Subject: RADIO Certification of VO8364AA+

Product (PMN): **VO8364AA+**

[Hardware modifications of radio module VO8364A becoming VO8364AA+](#):

Was	Becomes
 RF part	 RF Part : inversion of the LAN and the filters

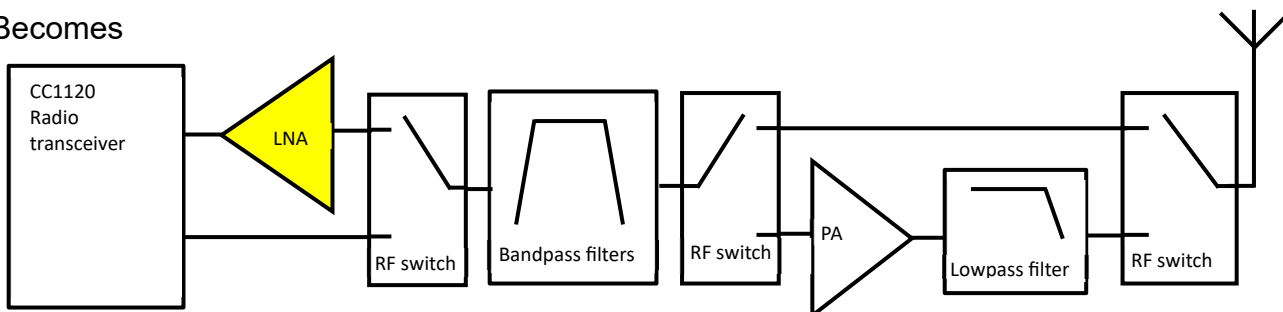
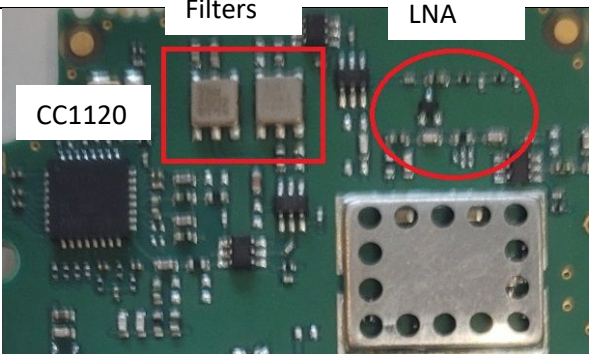
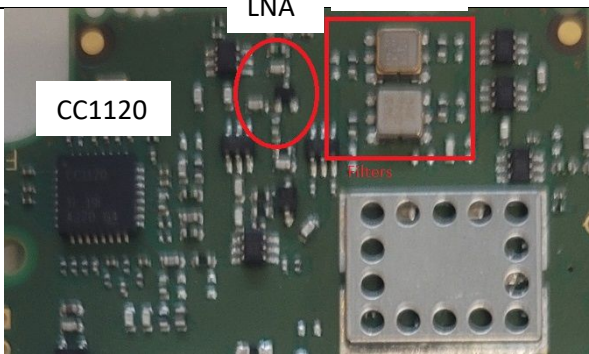
To improve resistance to interference (Better Blocking), RF filtering has been placed before the LNA in the receive chain. **No changes have been made to the transmission chain.** The schemes below show the changes:
